To: Regional Managers/Regional Engineers
From: Robert Ball, Technical Director 
CC: Gary Griggs, Frank Vacca, Scott Jarvis, Ben Tripousis, Diana Gomez, Michelle Boehm, Lisa Marie Alley, Boris Lipkin, Thierry Prate, Melissa Dumond, Mark McLoughlin, Lisa Nungesser, Ofelia Alcantara, Bruce Armistead, John Popoff, Simon Whitehorn, Dominique Rulens, HSR Environmental & Engineering Team Task Leads
Date: September 7, 2016
Subject: Notice to Designers No. 13 - Station Platform and Track Layout

STATION PLATFORM AND TRACK LAYOUT
 INTERMEDIATE STATION WITH HIGH-SPEED TURNOUTS
 (NOT APPLICABLE TO JOINT FACILITY AT LAUS AND 4TH/KING STATIONS)

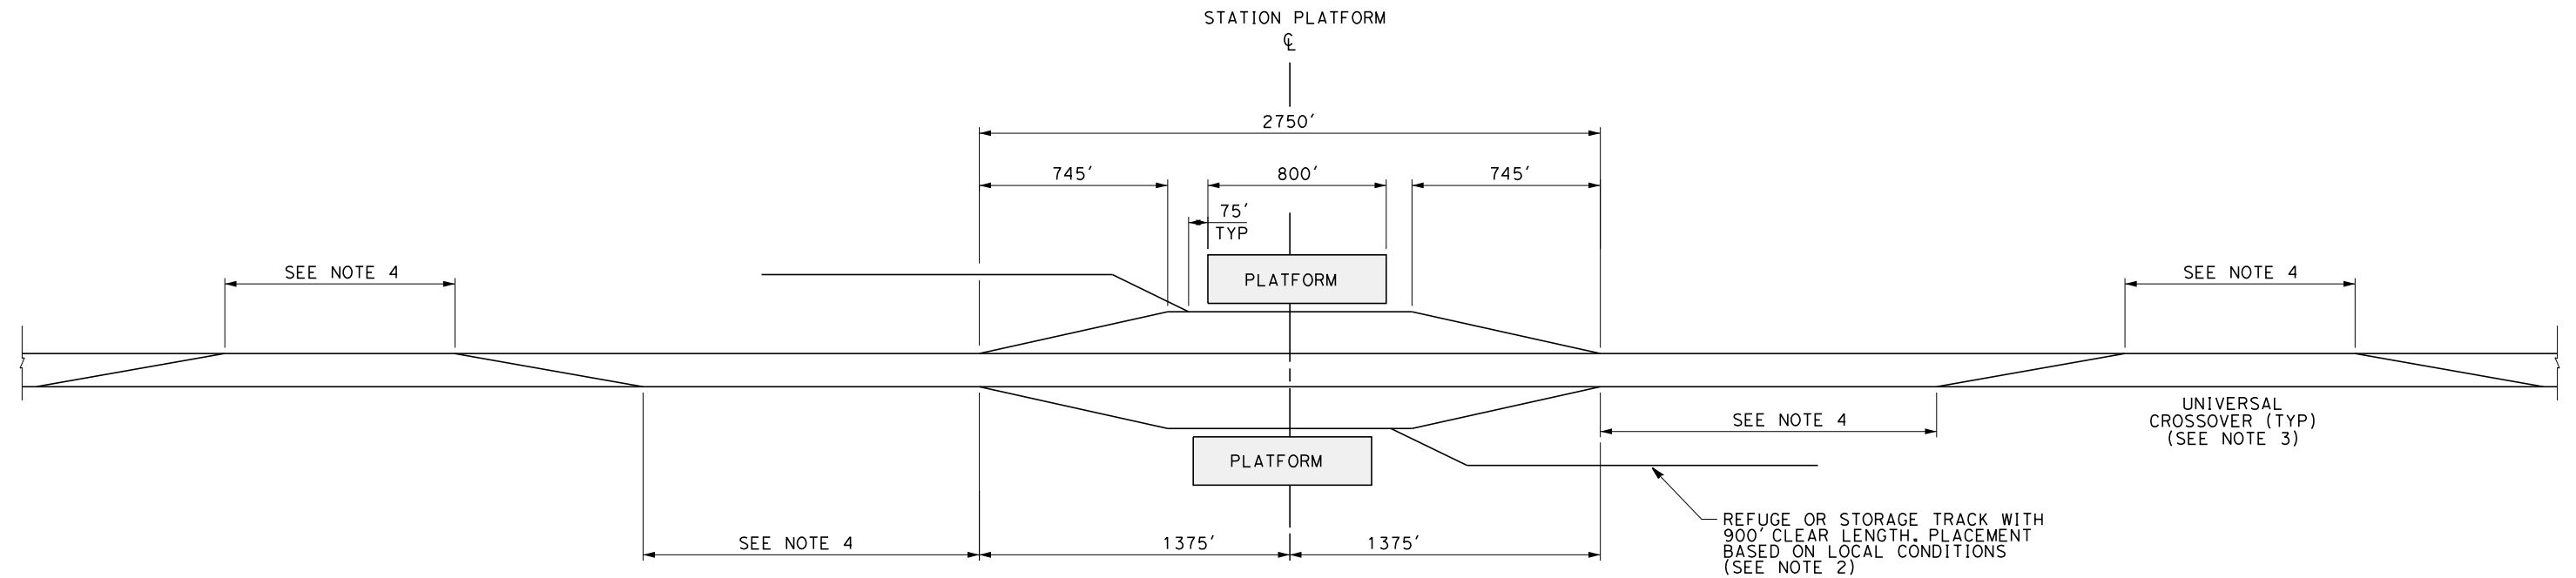
1. Modify the Usable Platform Length from 1,410 feet to 800 feet. Minimum and Exceptional values are omitted.
2. The station platform track between entry turnout and the exit turnout along the main track shall have a 2,750 foot minimum length centered symmetrically on the midpoint of the station platform.
3. Modify refuge track or storage track length from 1,650 feet to 900 feet clear length.

These guidelines are not applicable for joint facility stations (e.g. 4th and King or LAUS) where the platform length should be the same as the other rail operators in the facility, but not shorter than 800 ft.

1. 60 MPH DESIGN SPEED FOR STATION TRACK TURNOUTS.
2. PROVIDE TWO REFUGE OR STORAGE TRACKS, EACH 900' MINIMUM. THE REFUGE OR STORAGE TRACK CAN BE LOCATED IN ANY QUADRANT OF THE STATION. EACH 900' REFUGE OR STORAGE TRACK IS PROVISIONAL WITH 50' SPACE FOR BUMPING POST AND SAFETY BUFFER ZONE AND 50' SPACE FOR RESCUE VEHICLES.
3. PROVIDE UNIVERSAL CROSSOVERS BETWEEN MAIN TRACKS AT EACH SIDE OF STATION TRACKS.
4. FOR POINT OF SWITCH SPACING, SEE NTD 10 "SPACING BETWEEN CROSSOVERS AND TURNOUT" DRAWING.
